1. Project Name: Kihei Beach SPP
2. Date of Inspection: June 16, 2004
3. Inspection Personnel:

CONTINUING ELIGIBILITY INSPECTION (CEI) REPORT
FOR HURRICANE & SHORE PROTECTION PROJECTS

KIHEI BEACH, MAUI, HAWAII

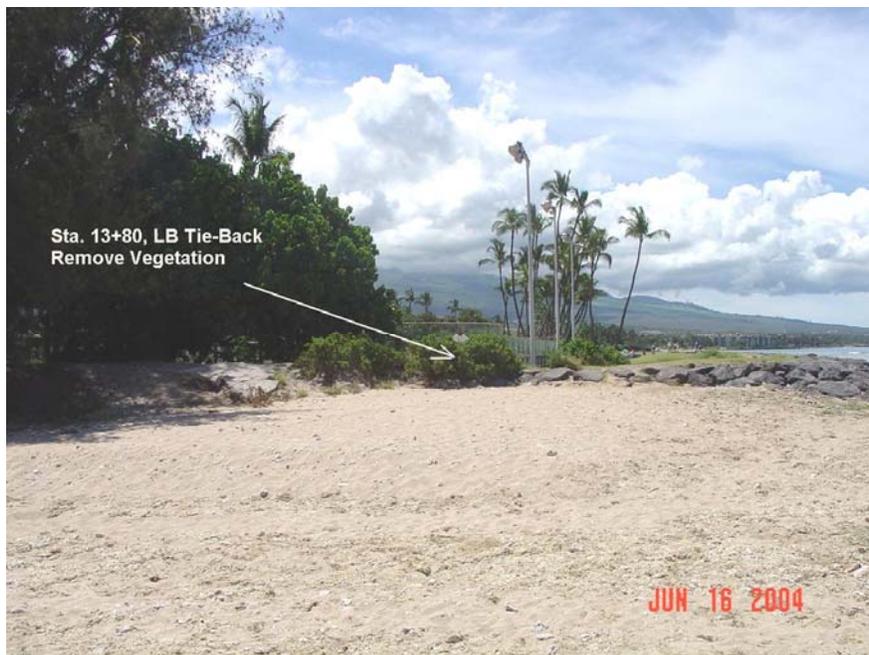
- i. Sta. 10+00, Remove 2ea. bushes from revetment crest.
